Template for corrections DA on test methods

Compilation by SWGs chairs	Proposal	indicates who tabled this proposal
Replies by CION	To be assessed	means to be assessed and possibly corrected by amending act
	OK	means to be corrected by the OJ Pub. Office

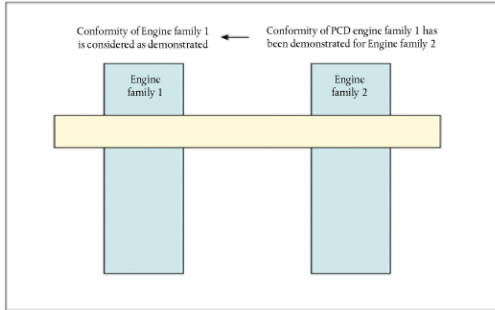
Annex IV	1	10.3.1.	The compliance of the warning system activation shall be demonstrated by performing two tests: lack of reagent, and one failure category considered in sections 7. to 9.. Why only two tests are required? This seems clearly insufficient, given that reference is made to a total of 4 areas o Lack of reagent o Errors from 7 to 9		DE proposal Not accepted. Policy decision agreed by QSG and consistent with HDV legislation. The approval authority chooses a number of items to check, but it is not practical / proportionate to check all items.
Annex IV	2	Sections 2, 3, and 4	DE Comments For DE Komments, see document: Anmerkungen BMVI zu Dokument ST 15755-16Add1 Stand 2017-01-20		Accepted For all amendments to Appendix 2, see document: 2017-654_Annex_IV_Appendix
